AMENDMENT SCOPE OF WORK:

Amendment to Special Use Permit
Round House Hotel Building

Sheet 7 of 19

Round House at Beacon Falls

2nd Floor Plan

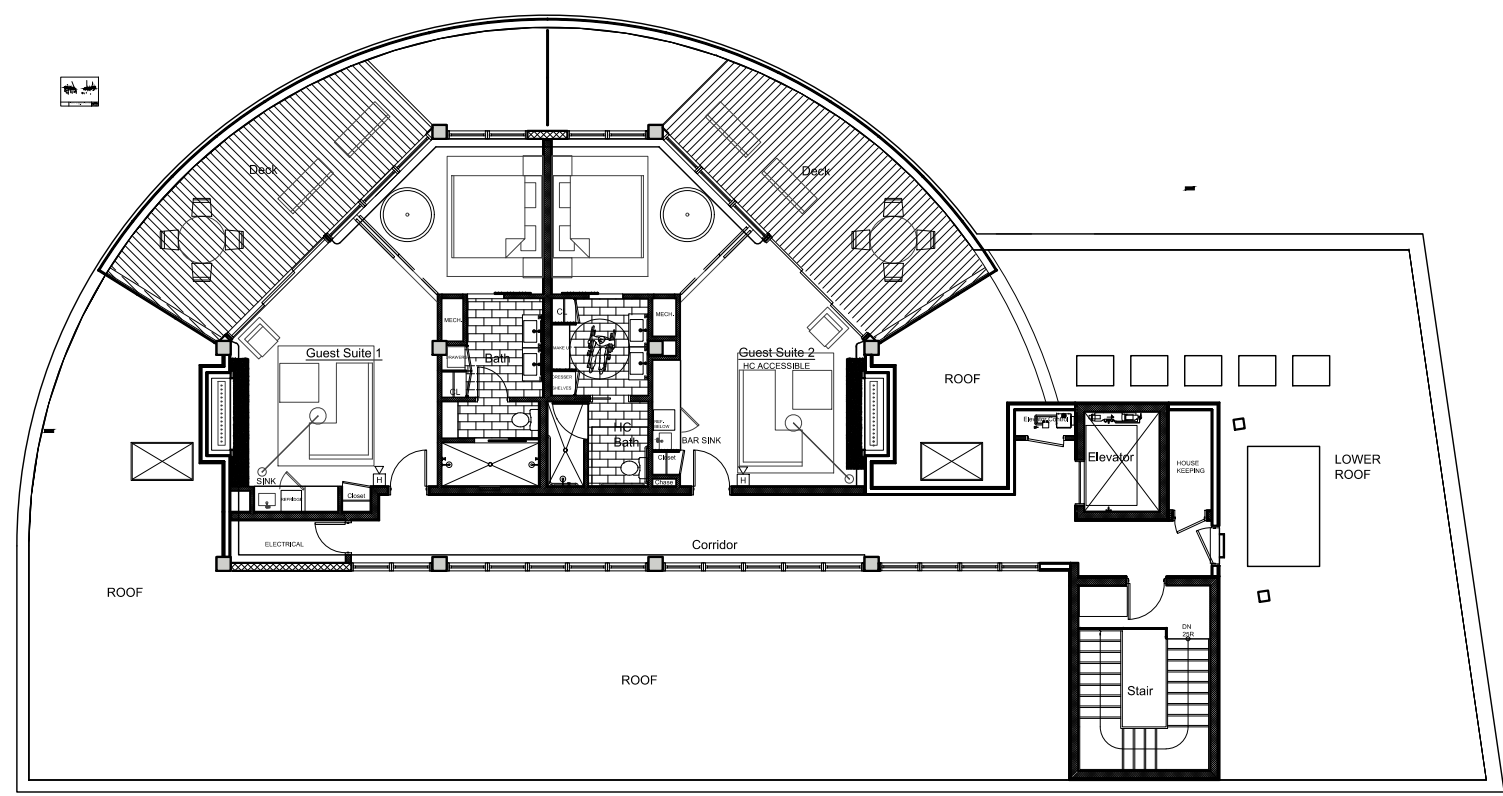
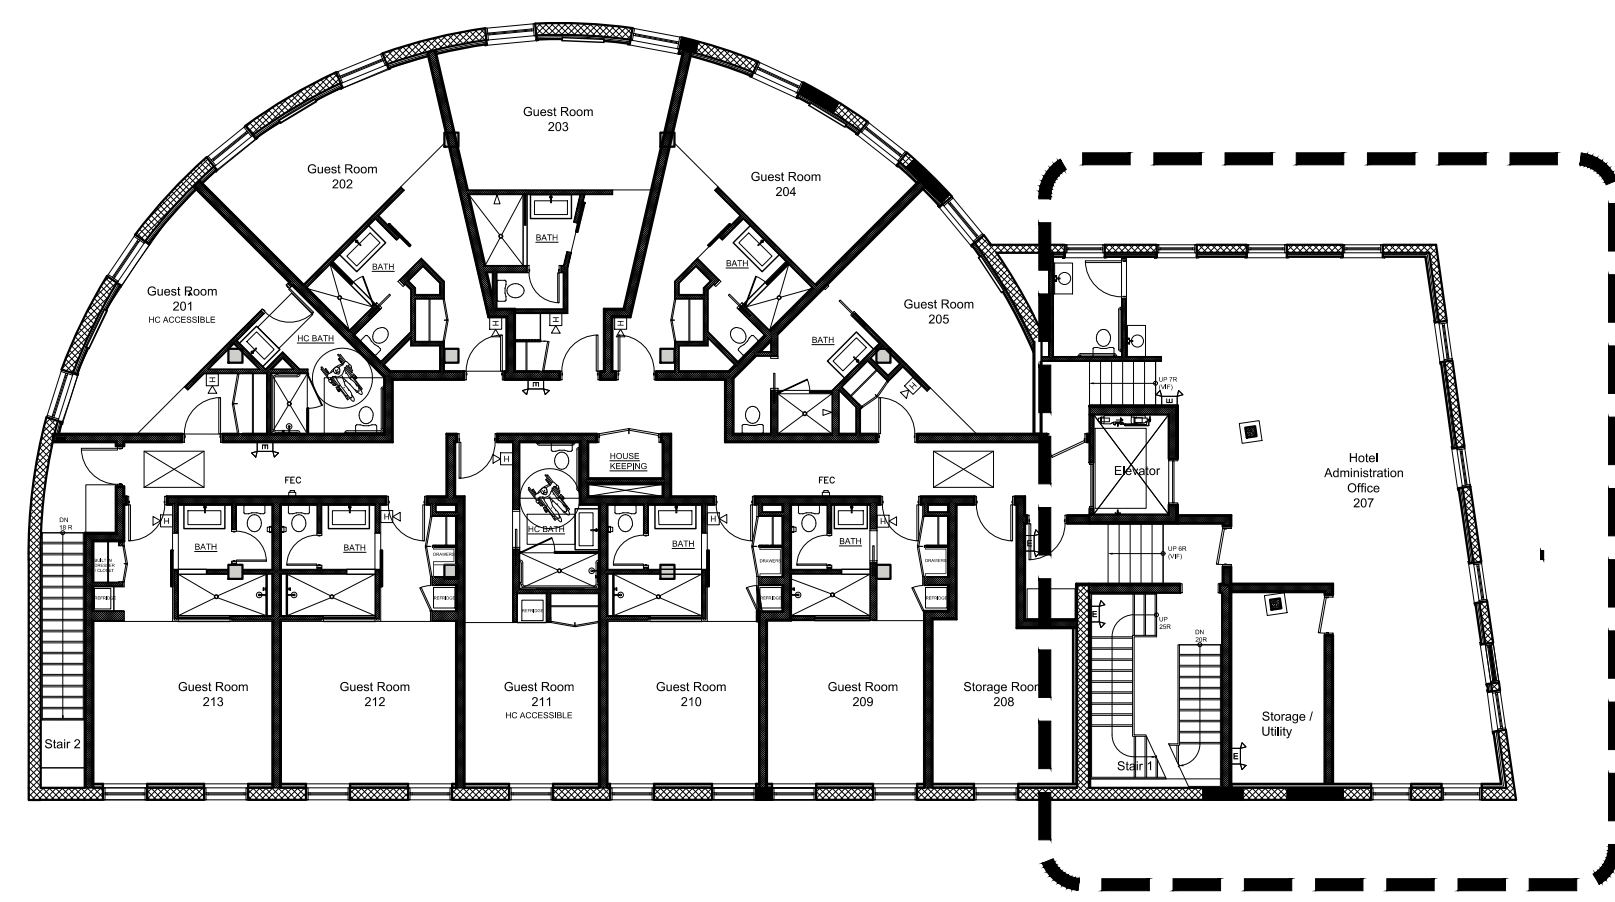
REPLACE PRIVATE DINING ROOM WITH HOTEL ADMINISTRATION OFFICE SPACE.

PARKING COUNT IS REDUCED BY 12 SPACES AS A RESULT OF ELIMINATION OF PRIVATE DINING ROOM.

NO ADDITIONAL PARKING IS REQUIRED FOR THE HOTEL ADMINISTRATION OFFICE SPACE
